**ORDINANCE NO. 5088**

**AN ORDINANCE APPROVING A TENTATIVE SUBDIVISION FOR A 280 LOT, PHASED SINGLE-FAMILY DETACHED RESIDENTIAL DEVELOPMENT AT THE NORTHEAST QUADRANT OF THE INTERSECTION OF NW HILL ROAD AND NW BAKER CREEK ROAD**

The Planning Department received an application (S 1-19) from Stafford Development Company, LLC requesting approval of a Tentative Subdivision (more than 10 lots) for a 280 lot, ten phase single-family detached residential development; and

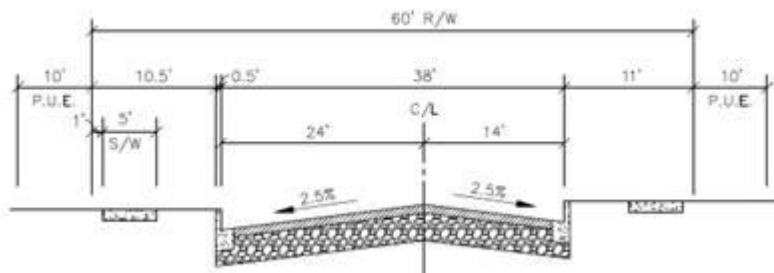
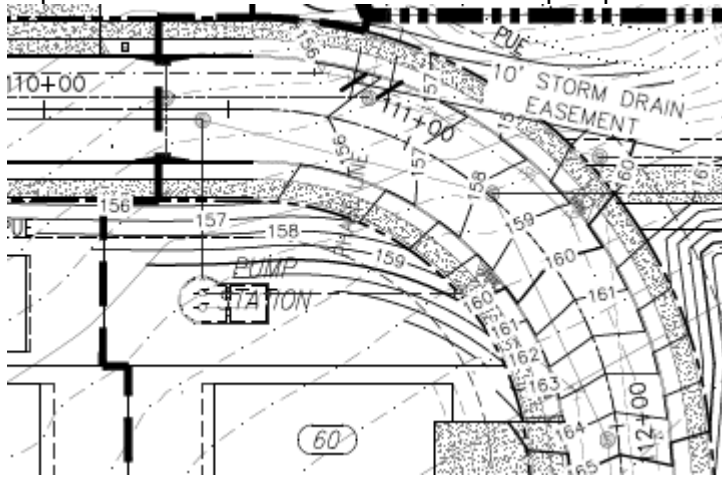
- The proposed intersection of Gregory & Augustine Streets shall be redesigned such that the intersection angle is as near to 90° as practical. The current “Y” configuration is not consistent with MMC Section 17.53.101(F):

- MMC 17.53.101(O) indicates that the public alley in the City’s street standards applies to commercial and industrial districts, not to residential developments. Thus, the proposed alleys on the proposal shall be private, and shall be maintained by the adjacent property owners or the Home Owners Association.
- Meadows Dr and Shadden Dr are proposed to have an offset crown to accommodate a right turn lane (see cross-section below). We would prefer see the City’s typical “Teepee” section so that the curb elevations match on each side of the street.
